(Shoreham Nuclear Power Station,  
Unit 1) )

PREPARED DIRECT TESTIMONY OF  
GREGORY C. MINOR AND DALE G. BRIDENBAUGH  
ON BEHALF OF SUFFOLK COUNTY

SUFFOLK COUNTY CONTENTION 28(a)(i)

SOC CONTENTION 7.A(1)

CONCEPTUAL DESIGN  
HPCS INITIATION CIRCUIT  
USING RELAY LOGIC  
(SOLID STATE LOGIC IS EQUALLY ADAPTABLE)

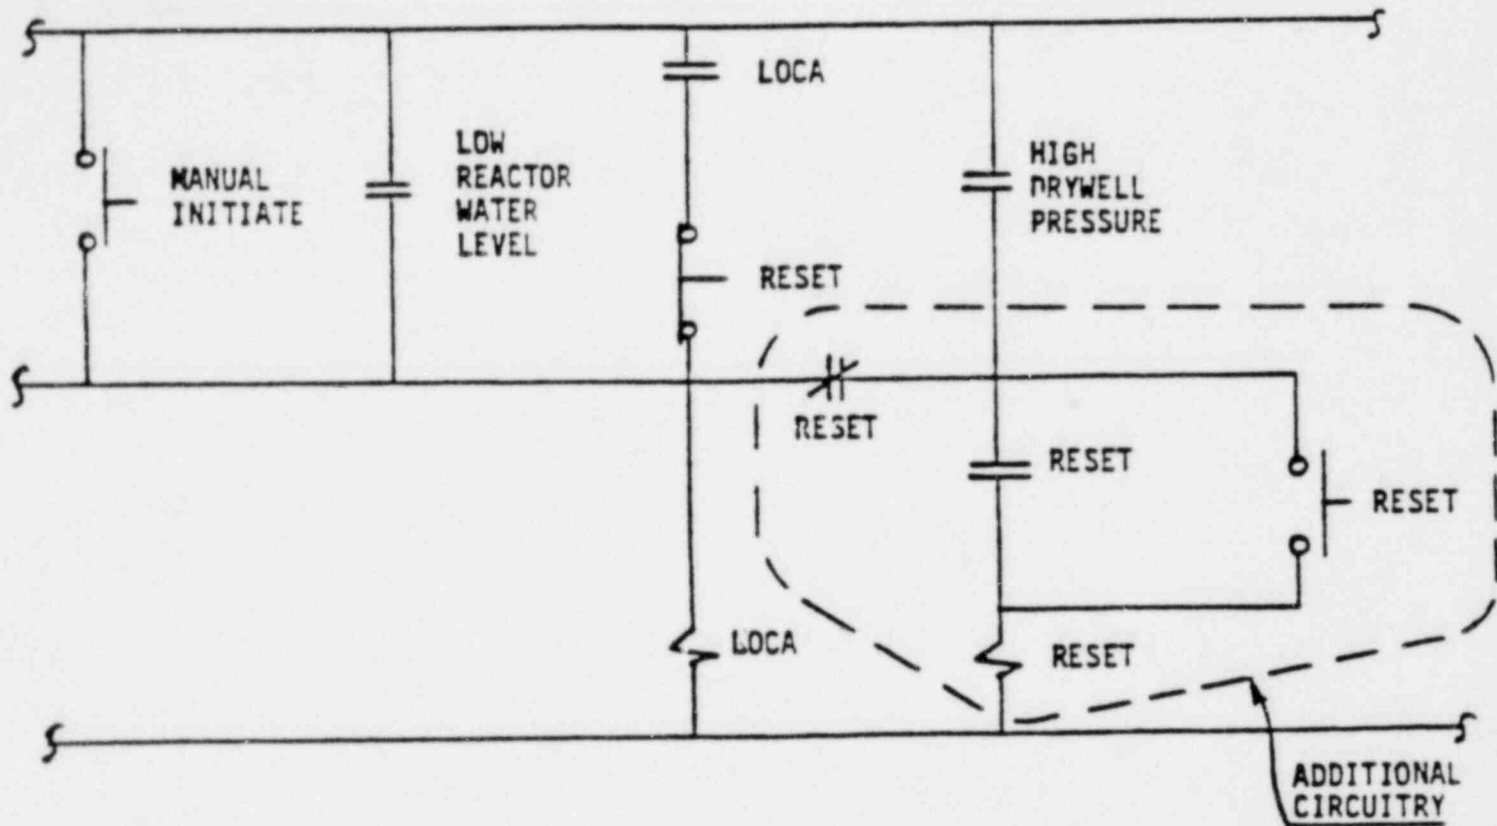
With regard to automatic restart of the HPCS after manual termination, we have reviewed the logic modification proposed in Appendix A to the reference Owners' Group submittal and we feel that the modification should be made on all BWRs with HPCS systems. The modification is simple and straightforward and results in a safety improvement at little cost.

The feature being considered will reset the auto initiation signal, on level and block the continuing auto initiation signal based on high drywell pressure. This will allow auto EPCS restart on low level after operator stop of the pump. It does block auto restart on high drywell pressure unless drywell pressure decreases below the setpoint and again increases above the setpoint. A decrease in drywell pressure below trip level will remove all reset features and return EPCS logic to the original status. The EPCS pump is not stopped automatically by any reset. Pump stop still requires operator action.
